United States Department of the Interior

U.S. GEOLOGICAL SURVEY
Reston, Virginia 20192

As requested by the Federal Emergency Management Agency (FEMA), attached is the review by the U.S. Geological Survey (USGS) of the model prepared for a reach of the Congaree River in South Carolina. The area covered by the model is for the reach of the Congaree River spanning the area north and south of highway I-77 embankment in Columbia, South Carolina.

The following documents were reviewed by Janice M. Fulford of the U.S. Geological Survey for technical clarity and accuracy:

Figure 1. Model boundaries, bridge opening locations and dike break locations from the Exponent RMA2 model of the Congaree River.

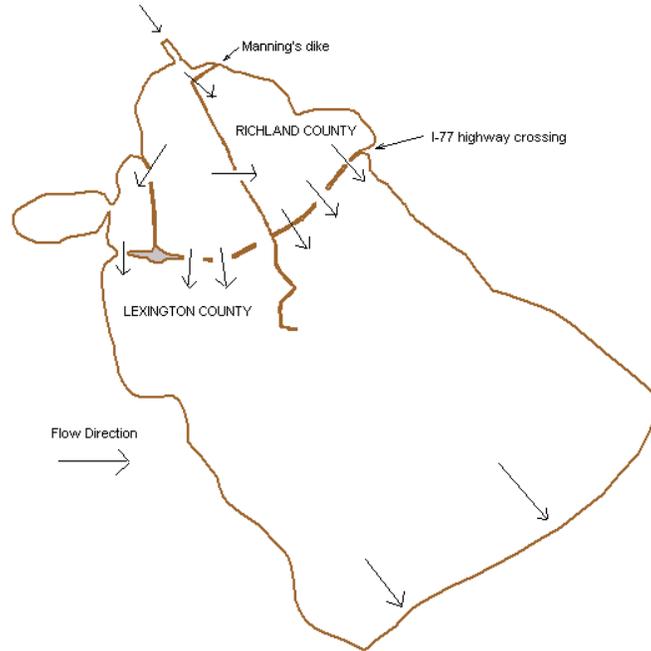
IV. The Exponent model does not accurately determine the portion of the 100-year flood flow passing through the Manning's dike breaks onto the Richland side of the flood plain. The Exponent model has local computational errors that produce significant errors in the flow computed through the bridge and dike openings. The sum of the flows passing through the dike breaks and the Lexington I-77 bridge openings (figure 1) should equal the total discharge of 292,000 cubic feet per second (cfs). Also, the flow through the dike breaks should equal the flow through the Richland I-77 bridge openings, and the sum of the flows passing through the I-77 bridge openings should equal the total model flow of 292,000cfs. The mass conservation error computed by summing the Manning's dike breaks and Lexington county bridge openings discharges and comparing it to the 100-year flood flow is about 17%. The finite-element method used by RMA2 does not guarantee local mass conservation. It is standard finite-element modeling practice to include flow (continuity) check lines to determine if mass is being adequately conserved locally. Poor local mass conservation can be due to poorly constructed model grids. Table A lists the discharges through the various bridge openings and dike breaks computed by using the Exponent model flow check lines and one hand calculation. Note that the flow through the dike breaks differ by 16% from the flow through the Richland Bridges, indicating that mass is not being properly conserved at the embankment openings.

Figure 2. Comparison of roughness values and locations used for the Exponent and FEMA RMA2 models of the Congaree River.

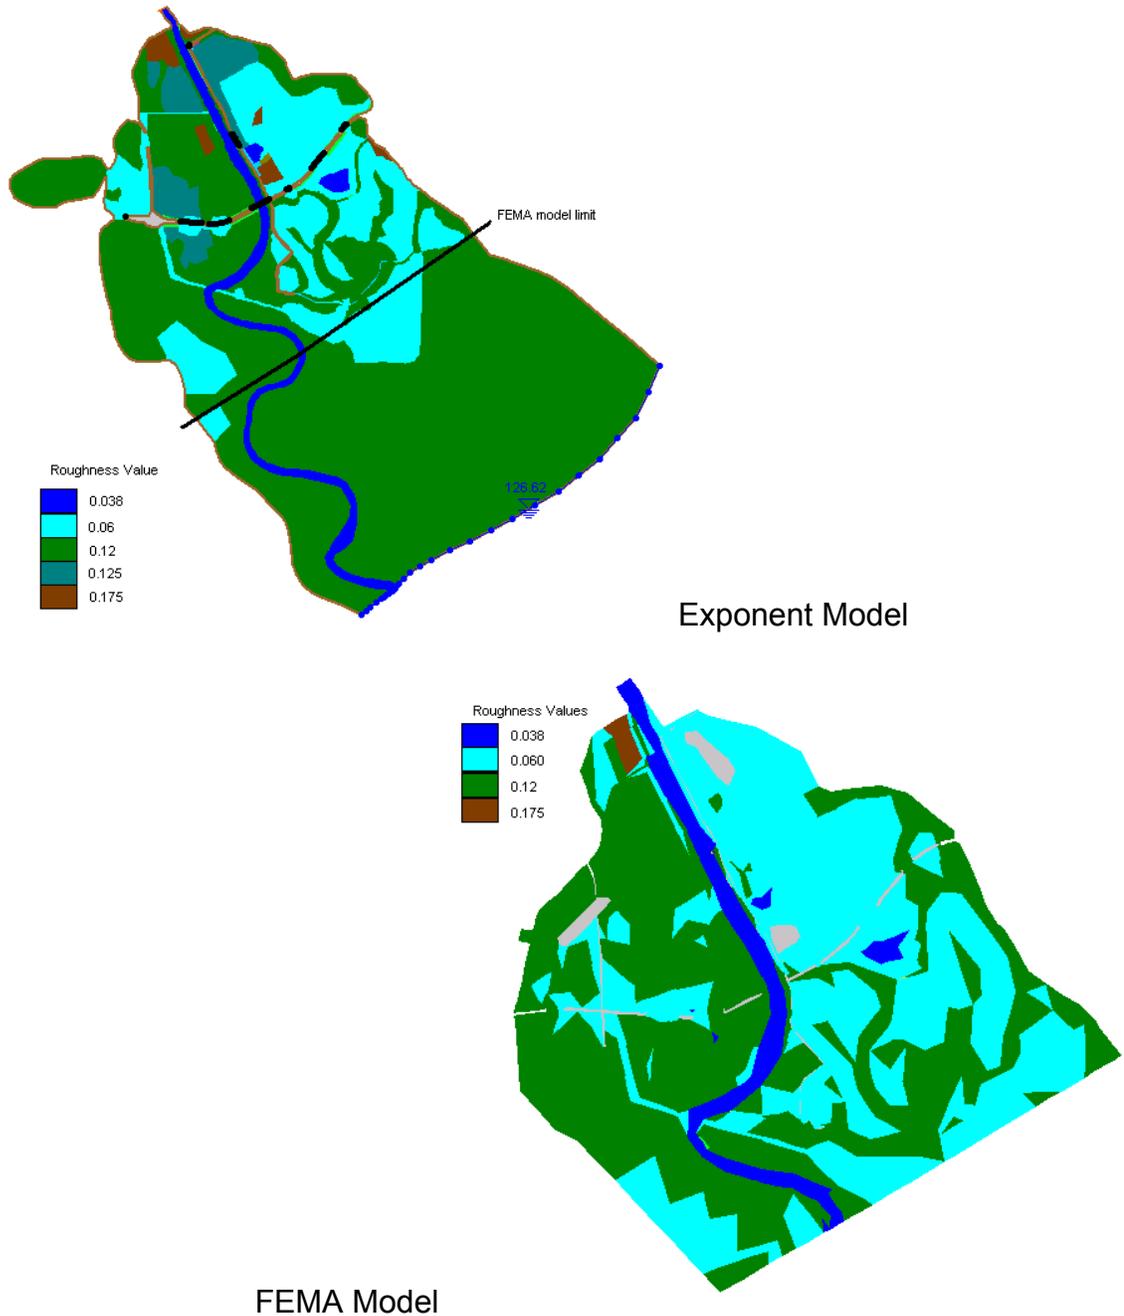
V. The Exponent model has increased the roughness coefficients (from 0.06 to 0.125) for elements just south of the portion of the Manning's dike that runs east west near the northern (upstream) limits of the model. Elements just north of Manning's dike in this area were also assigned larger roughness values (from 0.06 to 0.175). No information is given to support increasing the roughness values in this area of the model. Aerial photos (dated 01.21.1994 found on the web at terraserver.homeadvisor.msn.com, jpeg file attached NElevee.jpg) appear to show open cropland south of the levee. The area in the photo is similar in appearance to model areas that have roughness values of 0.06. The recent photo (dated 3.22.1999, file name Congaree-SmallerFile.tif) used by the FEMA report does not seem to show a change in land use for that area. A small portion of the area in question can be seen in the recent photo just above the white text, 1"=3000'. The roughness values used in this area should be confirmed. Roughness

values can significantly change flow directions and flow depths. A comparison of the roughness values used for the Exponent model with those used for the FEMA model is in figure 2.

Figure 3. Rating curves estimated for Carolina Eastman gage.

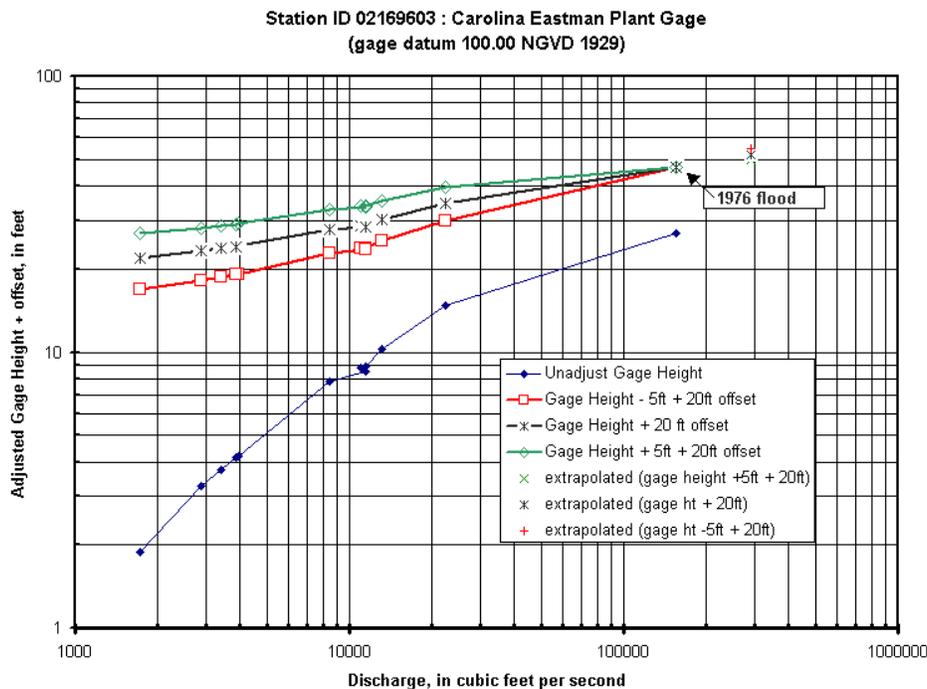
VI. The water-surface elevations computed by the Exponent model may be too low because of the outflow water-surface elevation used. Exponent Inc. used a constant water-surface elevation of

126.2 feet at the outflow boundary that may be from 0.5ft to 5.3ft too low when compared to water-surface elevations estimated from stage-discharge measurement analysis. The reason for selecting 126.2 ft was not documented in the materials accompanying the Exponent model. It is likely that this value is based on 1-dimensional (HEC2) model runs that used an energy slope for the boundary condition. A stage-discharge (rating curve) analysis was made on the measurement data collected by the USGS between March 1986 and April 1987 at the Carolina Eastman gage and included the 1976 flood elevation at the gage. Because the gage datum is referenced to a topographic map, gage heights associated with USGS discharge measurements at the gage have a possible error of ± 5 ft. The elevation at the gage for the 1976 flood was assumed to be accurate for the analysis. Figure 3 shows the rating curves developed from discharge measurements and the 1976 flood information. One curve, of gage height, has no corrections for datum and offset adjustments. The other three curves shown are computed with offsets of 20ft and referenced to a vertical datum of 100ft. Extrapolation of the three curves plotted with an offset gives a range of estimated water-surface elevations at the Carolina Eastman gage for 292,000cfs of 129.62ft to 134.53ft with 131.85ft for no datum correction. Because the Exponent model outflow boundary is located downstream of the gage, contours of the water-surface elevations estimated for the Carolina Eastman plant gage for the 100-year flood flow were plotted to check the boundary conditions used in the Exponent model. Figure 4 shows that the estimated elevations from the rating curve analysis are 0.5 to 5.3 ft higher than those computed by the Exponent model at the gage. Boundary conditions used by any flow model should be carefully selected and documented. Sensitivity of the model results to the likely range of water-surface elevations at the downstream outflow boundary should be investigated when the outflow water-surface elevation is not well known.

Figure 5. Contours of unit width discharge in cubic feet per second per one foot of width plotted for the Exponent RMA2 model.

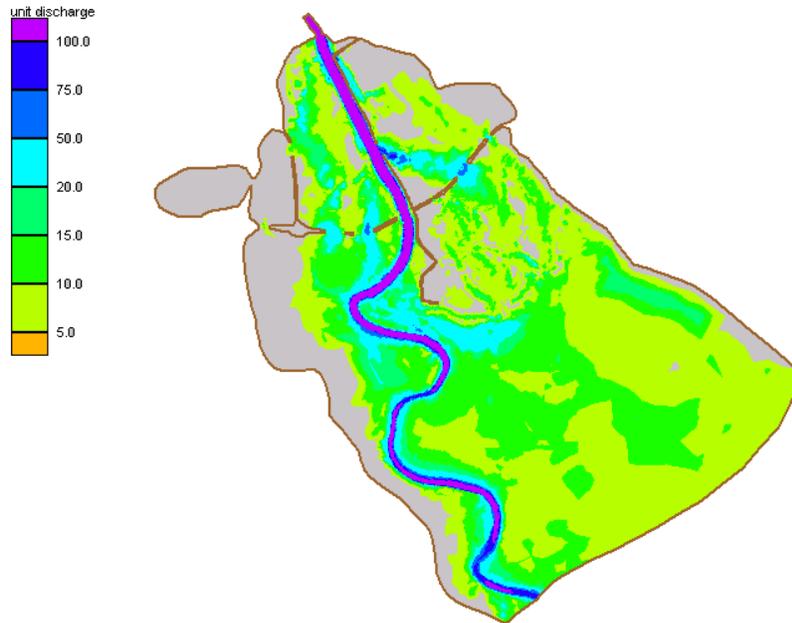
VIII. The conclusion by Exponent Inc. and [REDACTED] Consulting that the Richland side of the floodplain is not a floodway is not supported by the Exponent model results. Results from the Exponent model indicate that the Richland side of the flood plain conveys a significant portion of the 100-year flood flow. Table B lists the percent of total bridge flow passing through the main bridge opening and through the Lexington and Richland county relief bridges as computed by the Exponent model. Flow through the Richland relief bridges (63,074 cfs) is larger than the flow through the Lexington relief bridges (45,042. cfs). Additionally, contour plots of unit-width discharge show that a significant portion of the flow passes through the Richland side of the flood plain (figure 5). Most of the entire floodplain, including the Richland side, is inundated with flow depths of 8 ft or more (figure 6). Only 65% of the total modeled flow (292,000cfs) passes through the openings in the I-77 embankment on the

Lexington County side of Manning’s dike. This leaves a significant portion (35%) of the flow passing through the Manning’s dike breaks or computationally unaccounted for by the Exponent model (due to mass conservation problems).

Figure 7. Force per unit width in units of slugs per second squared computed from the Exponent RMA2 model for a flow of 292,000 cubic feet per second.

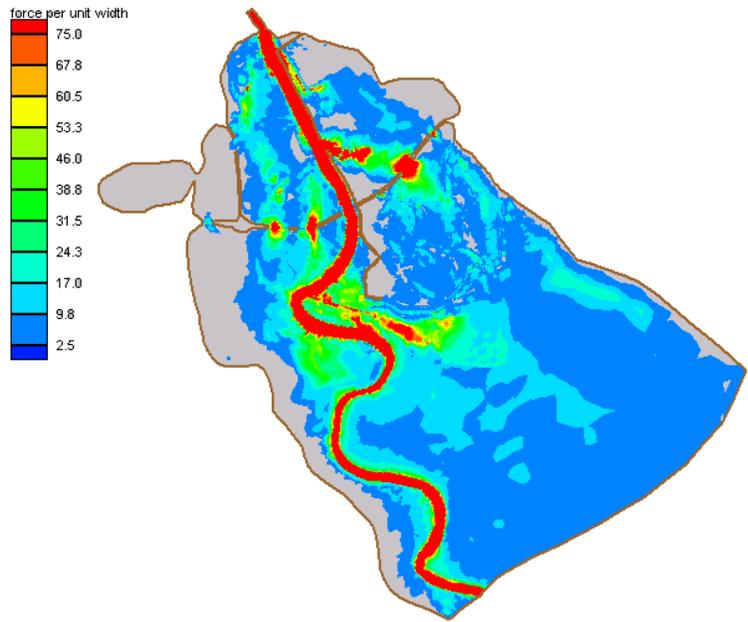
IX. The definition of a floodway used in the Exponent Inc. and [REDACTED] Consulting reports is questionable because the definition ignores the effects of any flow due to a natural or man made feature that is not parallel to the main channel. Flow distribution in broad floodplains is determined by the location of bridge openings in highway crossings and other topographic or roughness features in the flood plain. The Exponent Inc. and [REDACTED] Consulting definition restricts the floodway to be adjacent and parallel to the main channel and ignores significant flow features that aren't parallel and adjacent to the main channel. For example, if a flood plain had a distributary branch that carried one half of the flow but at a 90-degree angle to the main channel, that distributary would never be part of a floodway using the Exponent Inc. and [REDACTED] Consulting definition because flow in the distributary would not be parallel to the main flow. FEMA does recognize that significant flow patterns can occur in a floodplain that do not flow parallel to the main channel. The FEMA "Study Contractor Guidelines and Specifications" recommend, "Split-flow analyses should be considered when flows overflow the banks of the main stream and take a different flow path." Also the FEMA document states, "2-D computer models may be used for shallow flooding areas, split flow situations, and complex bridge sites." The I-77 highway crossing of the Congaree floodplain is a significant feature affecting flow distribution on the floodplain. Placement of the main bridge and the relief bridges largely dictate how the flow north and south of the highway crossing is distributed. The effect of the Richland relief bridges on flow patterns should not be ignored because FEMA "Study Contractor Guidelines and Specifications" dictate for uncertified levees that "the 100-year flood elevations will be recomputed as if the levee did not exist" and because Manning's dike is expected to "likely fail in a 100-year flood"(Appeal Resolution for Congaree River in Richland and Lexington Counties, South Carolina, FEMA, September 26,2000) based on geotechnical studies of the levees. The force exerted by water during a flood could be one of many factors considered when determining a floodway. Figure 7 is a contour plot of force per unit width computed from the Exponent model results using the equation $F = \frac{1}{2} \rho v^2$ where F is force, ρ is the density of

water (1.94 slugs/ft^3), y is the flow depth at a model node and v is the velocity magnitude at a model node. This plot shows that significant forces are produced by the flow present in the Richland County side of the Exponent model.
